Issue Date: October 19, 2022

Product Change Notification

Effected Parts	RC4004A Series
----------------	----------------

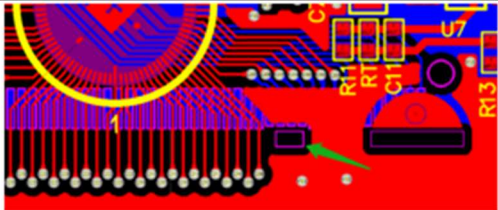
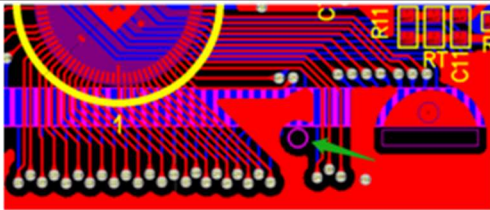
The metal frame increases the positioning column and the side seal opening

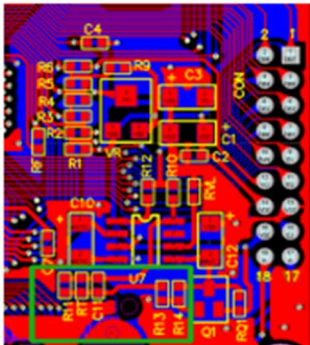
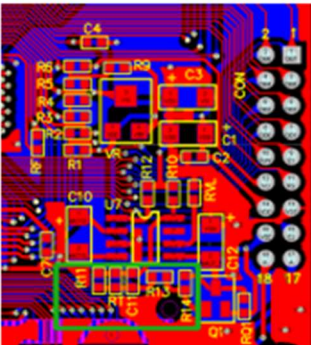
The positioning holes of the metal frame on the PCB are changed from square to round

Changes in the position of some components on the PCB
